**PLANNED UNIT DEVELOPMENT
& SUBDIVISION STAFF REPORT****Date: March 1, 2018****DEVELOPMENT NAME**

Somerby of Mobile Subdivision

CONTEMPLATED USE

SITE PLAN

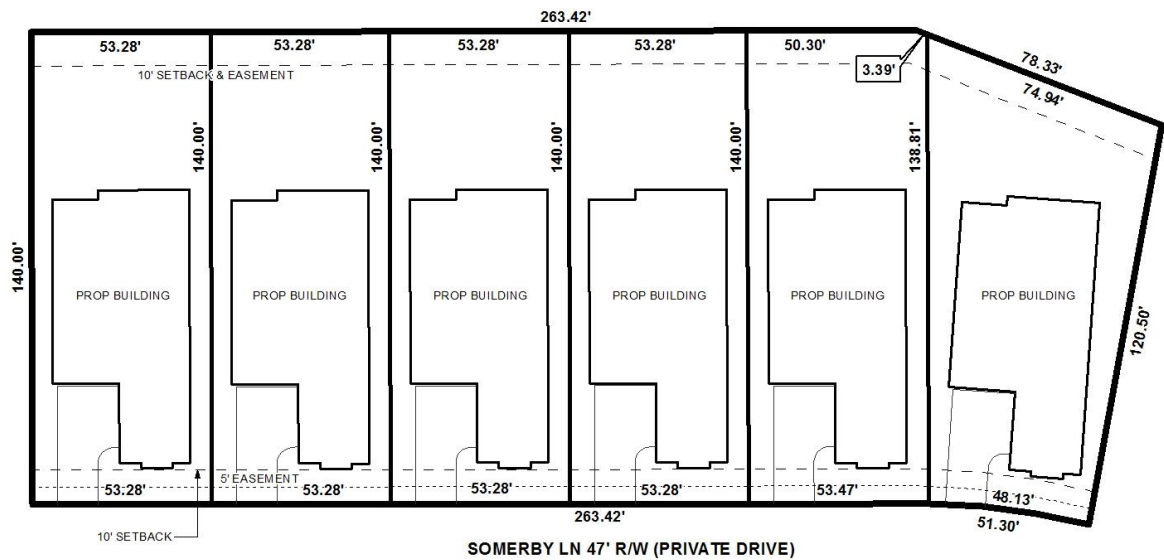
The site plan illustrates six (6) identical, 2,596± square-foot single-family dwellings. A 10' minimum building setback line is illustrated and reflects a similar design standard throughout the overall PUD site, thus facilitating approval of the request for reduced front yard setbacks. This information should be retained on any revised site plan submitted for review of any land disturbing or construction activities.

Side and rear yard setbacks for each lot are depicted on the site plan and meet the minimum yard requirements for lots within a B-1, Buffer Business District, per Section 64-3.E.1.e. of the Zoning Ordinance. This information should be retained on any revised PUD site plan.

The maximum building site coverage by all buildings within a B-1, Buffer Business District, is 45%, per Section 64-3.E.1.c. of the Zoning Ordinance. The site coverage of each proposed dwelling is depicted as being 35%± or less, thus meeting site coverage limitations. This information should be depicted on a revised PUD site plan.

The sizes of the proposed lots, as mentioned, meet the minimum size requirements of the Subdivision Regulations as well as the Zoning Ordinance for lots located in B-1, Buffer Business Districts. The lot sizes are also illustrated in both square feet and acres on the site plan and should be retained on any revised site plan; or, provision of a table providing the same information on any revised site plan may suffice.

The site plan illustrates a right-of-way width similar to that depicted on the preliminary plat for the existing private street, Somerby Lane, which should be retained on any revised PUD site plan, if approved. Also, in coordination with the Subdivision plat, a note should be provided on the PUD site plan, if approved, stating that maintenance of the private street(s) is the responsibility of the property owners. An additional note should be placed on the Final Plat stating that, if the private street(s) is/are not maintained to City standards inasmuch as it/they could ultimately be dedicated for public use and maintenance, then 100 percent of the cost of the improvements required to do so shall be assessed to the property owners at the time the private street(s) is/are dedicated.

A 5' drainage, utility and landscape easement is illustrated along the frontage of each lot, and a 10' drainage and utility easement is illustrated along the rear yard of each lot. If approved, a note should be placed on the site plan stating no structures shall be built in any easement.

Finally, no trees or landscape areas are illustrated on the site plan. Full compliance with the tree and landscape area ordinances was required for several of the previously amended PUD requests, and sites within a commercial district, such as a B-1, Buffer Business District, are typically required to comply with tree and landscape area ordinances. However, the subject site is proposed to be developed with single-family residences, and is a use of the land that, if located in an R-1, Single-Family Residential District would not require compliance with tree and landscape area ordinances. Additionally, it appears trees and landscaping was mostly required for development of the commercially-developed portion of the PUD site (i.e. the age-restricted apartment complex). As such, compliance with tree and landscape area ordinances should not be required at this time; however, it should be noted that any trees or landscaping provided on the site should be illustrated on a revised site plan.

- 1) retention of the 10' minimum building setback line on the PUD site plan;
- 2) retention of the side and rear yard setbacks on the PUD site plan;
- 3) revision of the site plan to illustrate the 45% maximum allowable site coverage for each proposed dwelling;

- 4) retention of the lot sizes in square feet and acres on the PUD site plan, or provision of a table on the site plan providing the same information;

- 5) retention of the 47' right-of-way on the PUD site plan;
- 6) placement of a note on the site plan stating that maintenance of the private street is the responsibility of the property owners;

- 7) placement of a note on the site plan stating that, if the private street is not maintained to City standards, then 100 percent of the cost of the improvements required to do so shall be assessed to the property owners at the time the private street is dedicated for public use;

- 8) placement of a note on the site plan stating that the maintenance of all common areas, including any detention areas, is the responsibility of the property owners;

- 9) placement of a note on the site plan stating each lot is limited to one curb cut, with any changes to their sizes, locations or designs to be approved by Traffic Engineering and conform to AASHTO standards;

- 10) placement of a note on the site plan stating no structures shall be constructed in any easement;
- 11) compliance with Engineering comments: *(ADD THE FOLLOWING NOTES TO THE PUD SITE PLAN: 1) Any existing or proposed detention facility shall be maintained as it was constructed and approved. The Land Disturbance Permit application for any proposed construction includes a requirement of a Maintenance and Inspection Plan (signed and notarized by the Owner) for the detention facility. This Plan shall run with*
